Access Compliance Report

Public Rights-of-Way

Intersection ID: 27871	Main Street: HARRISON'S_CROSSING_AV	Cross Street: STRICKLAND_CT	Location:	N
ADA ID: 38F1DB37A8A7	Ramp Type: Perp	Initial Pass/Fail: Fail	Overall Compliance: No	Severity Score: 13.75
Codes/Mitigation Info/Possible Solution		Field Measurements/Component Compliance

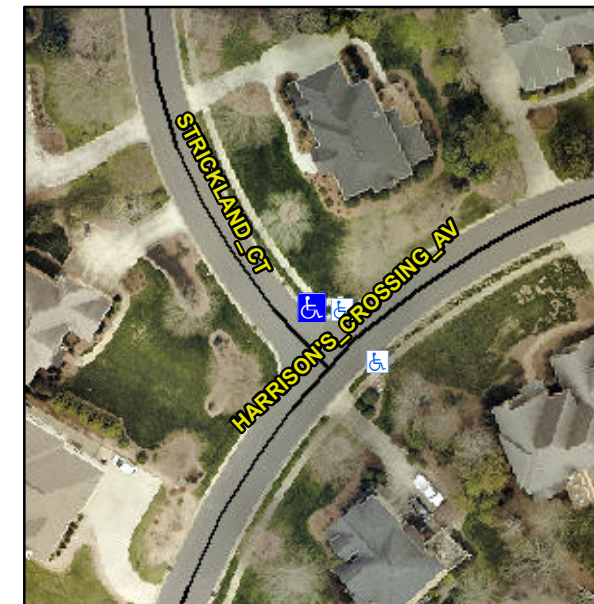
Not Found, R304.2.2, R304.5.3

Compliance	Description	Data	Compliance	Description	Data
N/A	Ramp Length (in)	52.0	No	Ramp Slope (%)	10.0
Yes	Ramp Width (in)	48.0	No	Ramp XSlope (%)	3.1
N/A	Flare Type LT	N/A	N/A	Flare Type RT	N/A
N/A	Flare Slope LT (%)	N/A	N/A	Flare Slope RT (%)	N/A
N/A	Flare Traversable LT?	N/A	N/A	Flare Traversable RT?	N/A
N/A	Landing Length (in)	N/A	N/A	DWS Provided?	N/A
N/A	Landing Width (in)	N/A	N/A	DWS Contrast?	N/A
N/A	Landing Slope (%)	N/A	N/A	DWS Length (in)	N/A
N/A	Landing X Slope (%)	N/A	N/A	DWS Full Width?	N/A
N/A	Landing Curb? (Y/N)	N/A	N/A	DWS Offset (in)	N/A
N/A	Shared Landing?	N/A			
N/A	Gutter Ponding?	N/A	N/A	Gutter Slope (%)	N/A
N/A	Gutter Lip Ht (in)	N/A	N/A	Gutter X Slope (%)	N/A
N/A	Painted X Walk1?	No	N/A	Painted X Walk2?	N/A
	X Walk 1 Direction	To SW		X Walk 2 Direction	N/A
N/A	X Walk 1 Width (in)	N/A	N/A	X Walk 2 Width (in)	N/A
	X Walk 1 Slope (%)	1.1		X Walk 2 Slope (%)	N/A
	X Walk 1 X Slope (%)	1.6		X Walk 2 X Slope (%)	N/A

Remove & Replace Entire Ramp.
